City of Sugar Creek

Addendum No. 1

RE: Lewis and Clark Expressway – Sterling Ave. Project
Sugar Creek, Jackson County
Federal Aid No.: DP-3400(408)

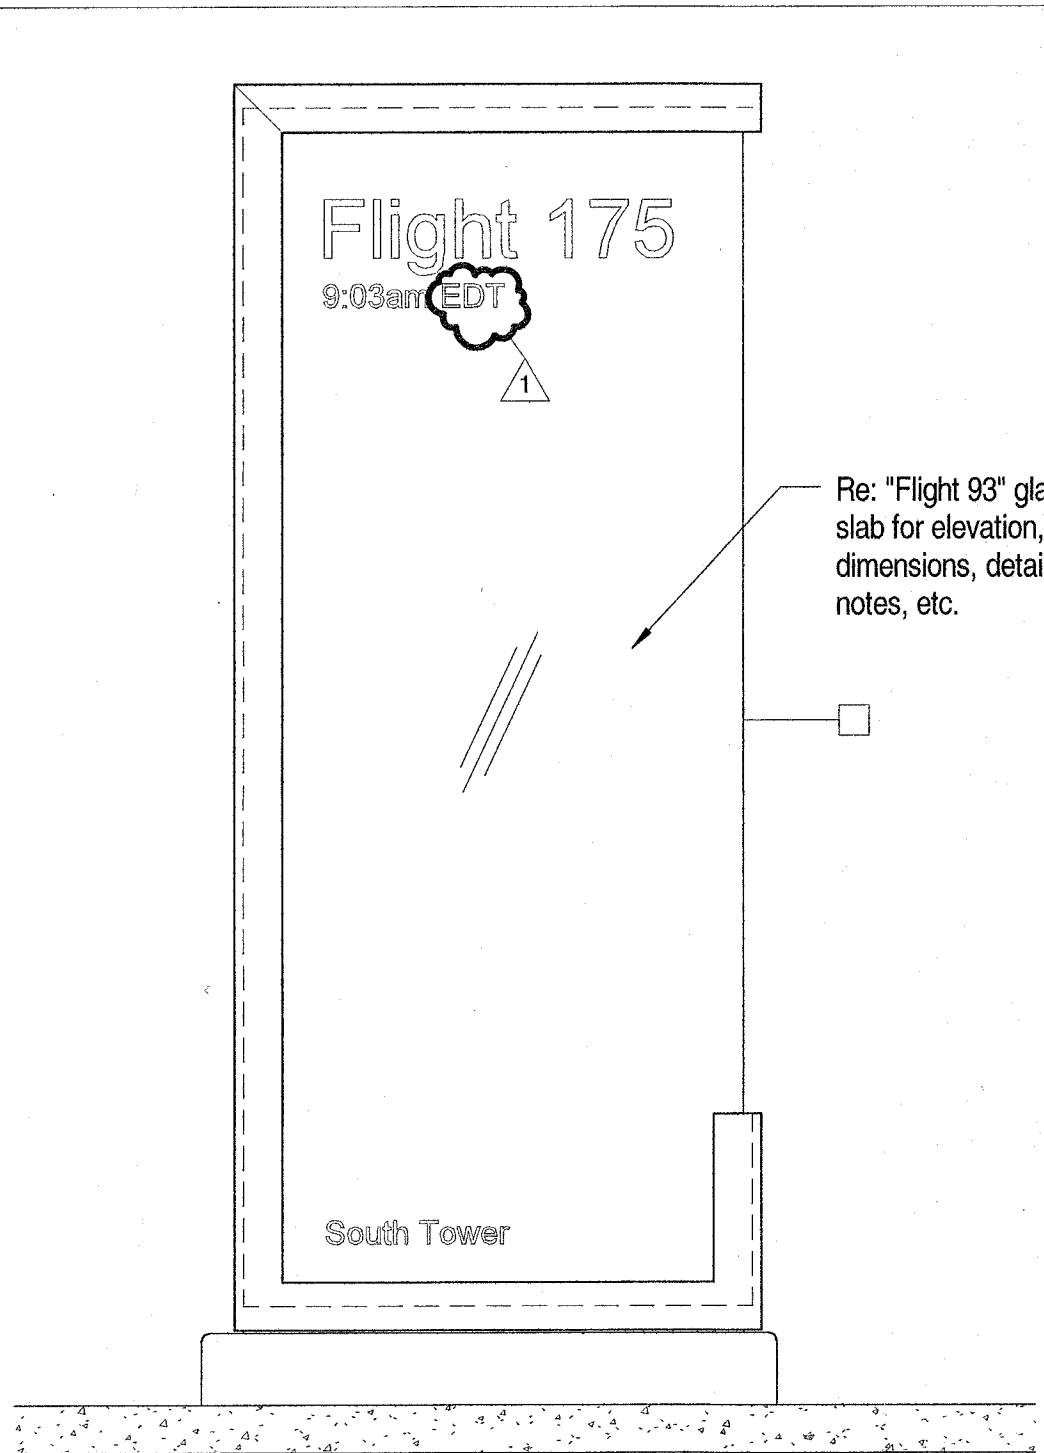
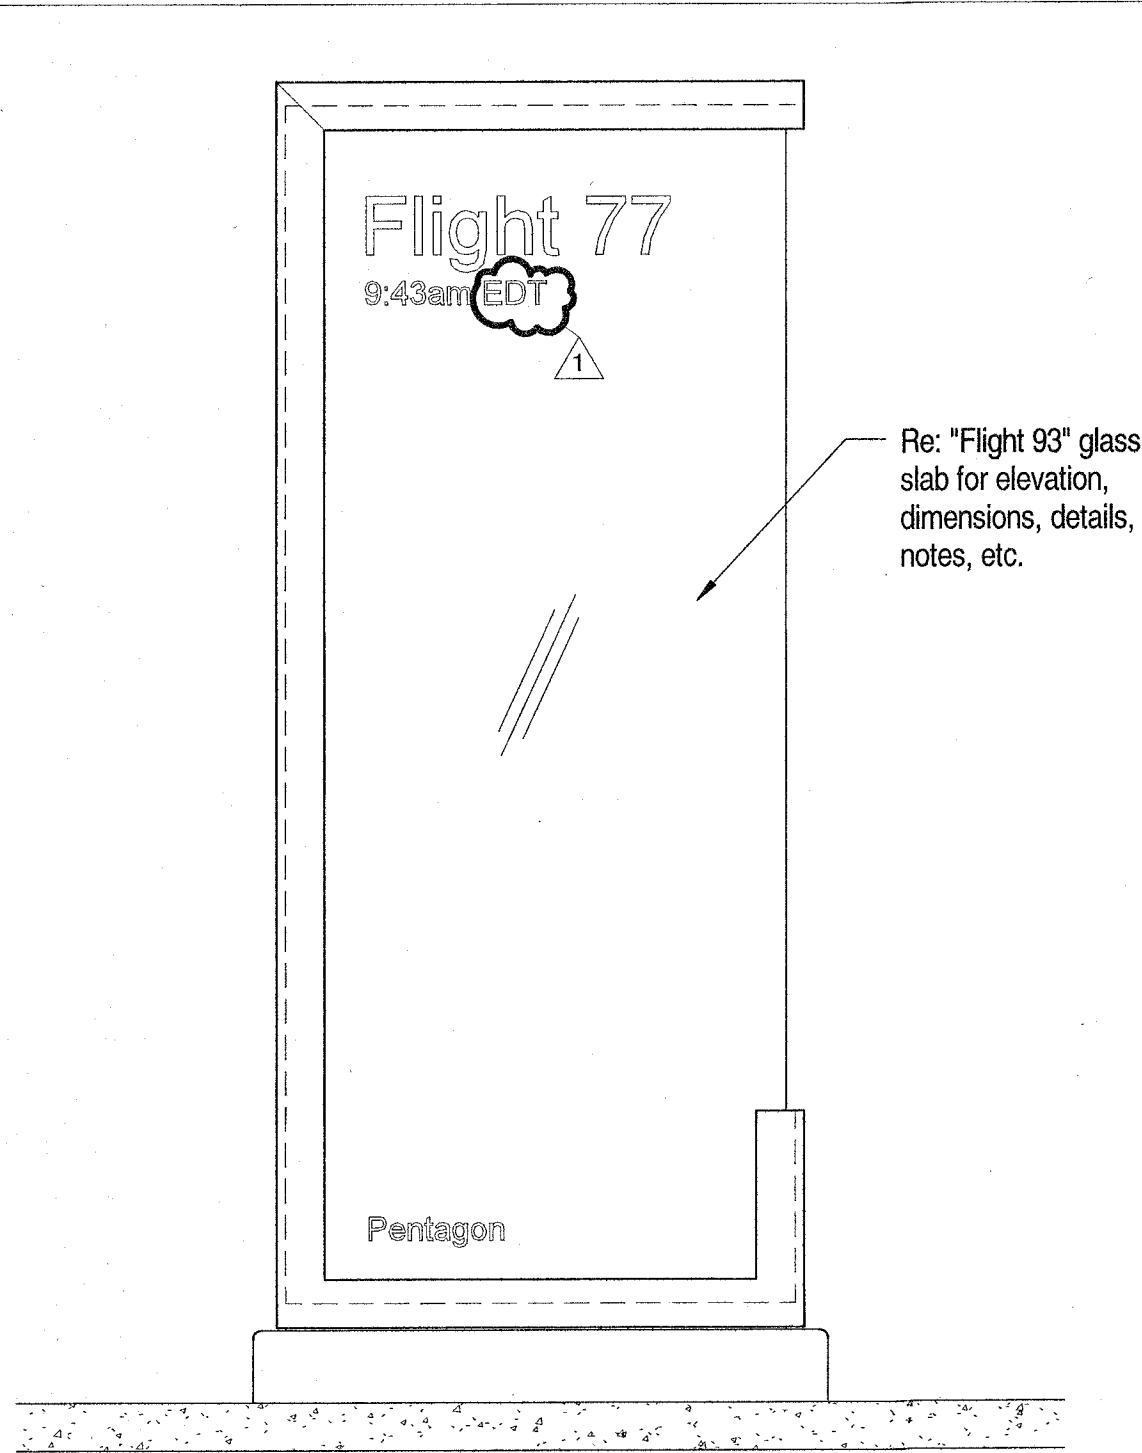
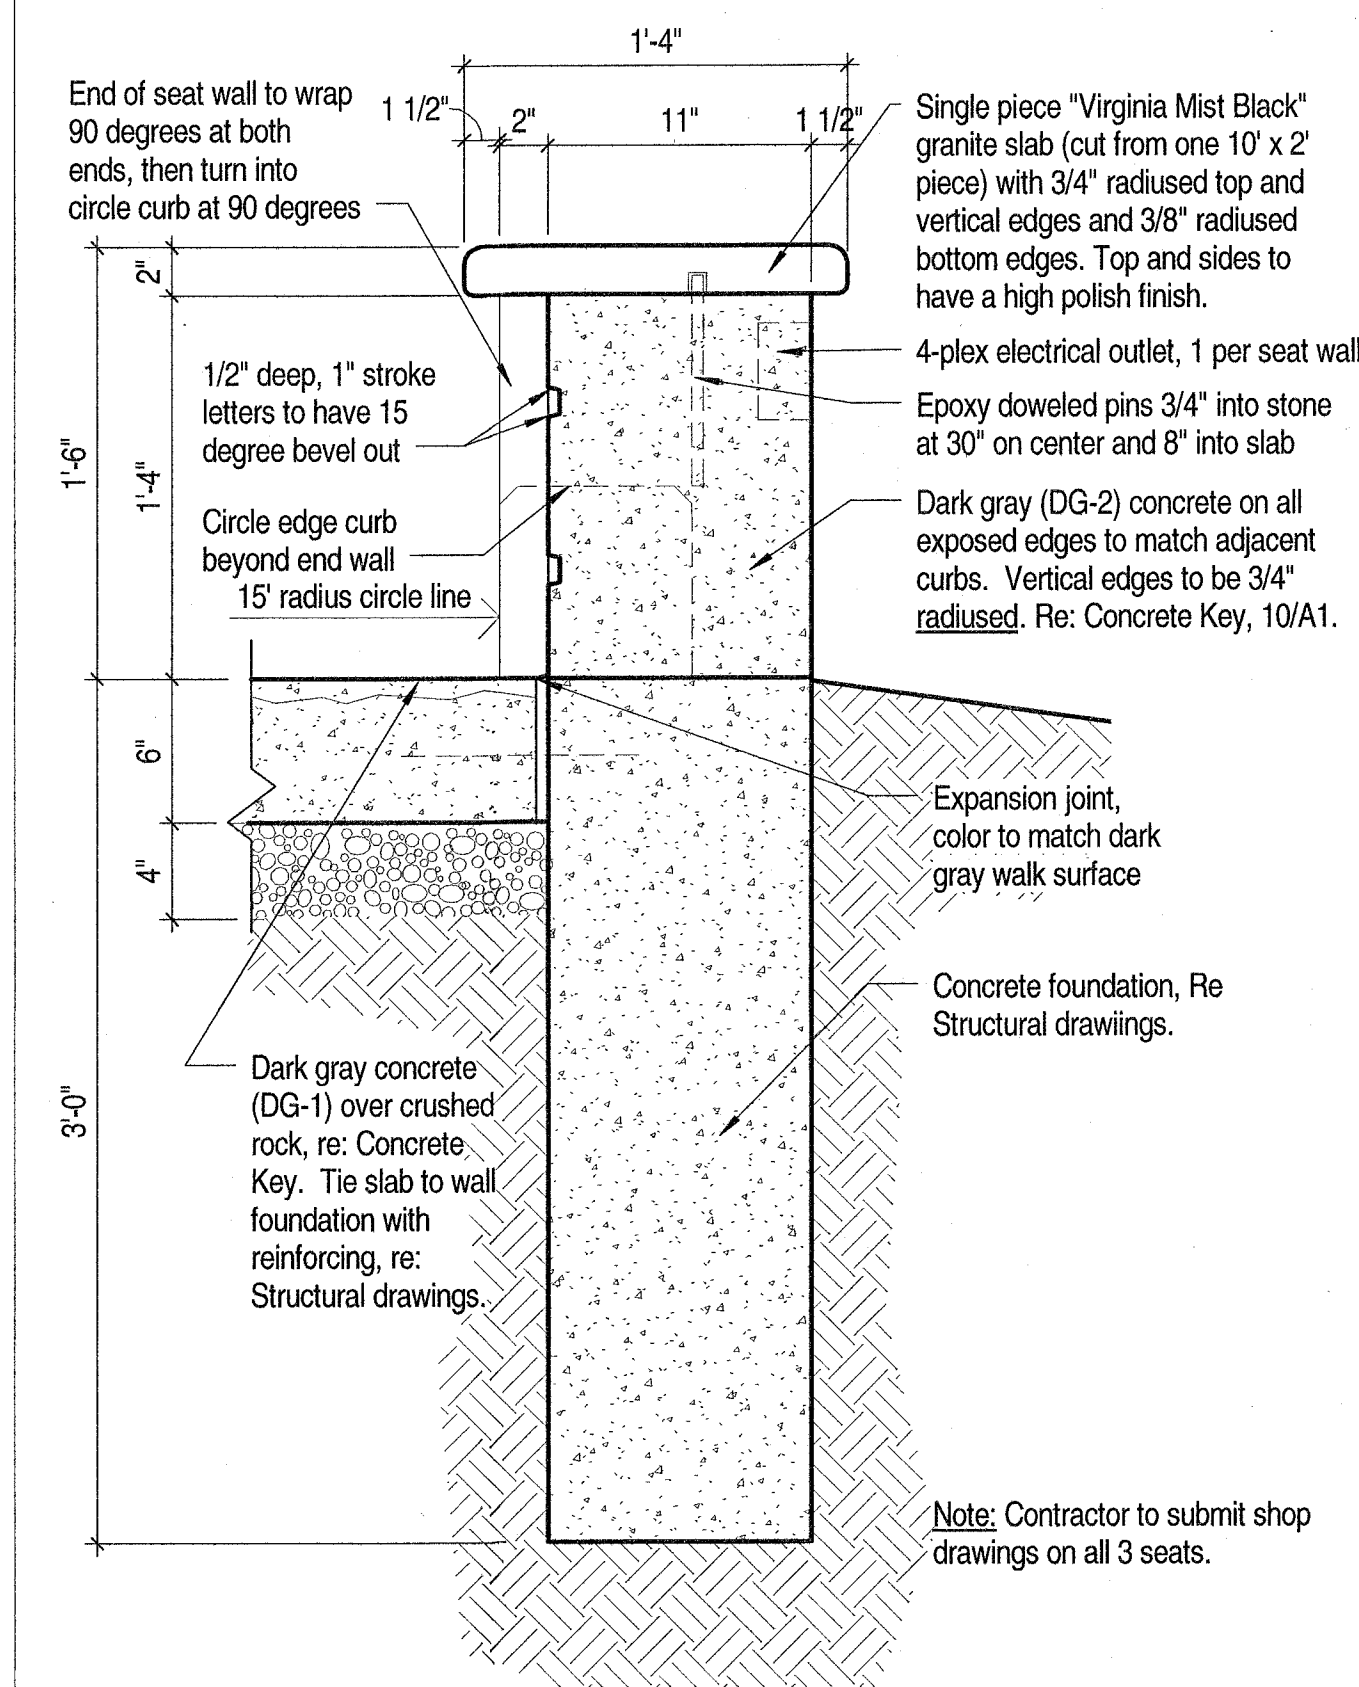
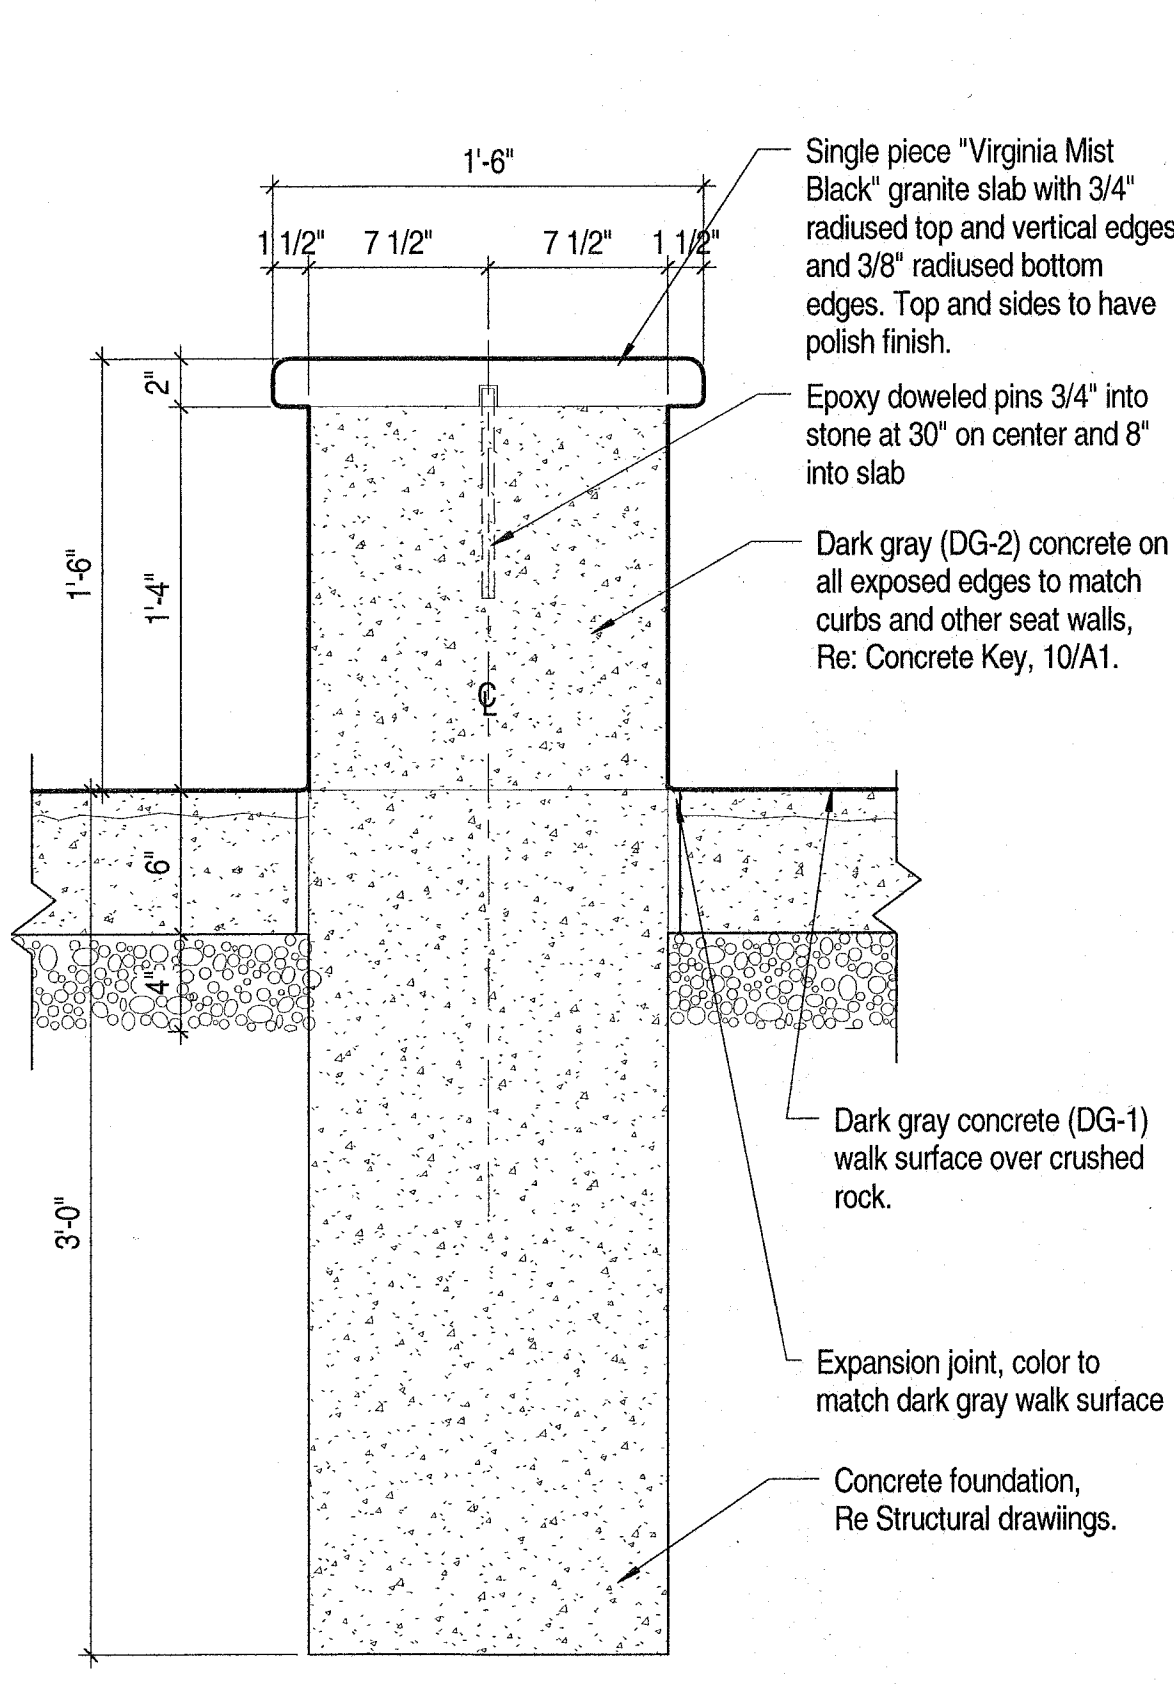
- c. A2 Glass Slabs and Seat Walls (Plan Set Sheet No. 59) – The drawings incorrectly indicated the time zone as being “EST” instead of the daylight savings time zone as “EDT”. The revised detail sheet is attached as 059_0A2_LCE_911DTL.PDF.
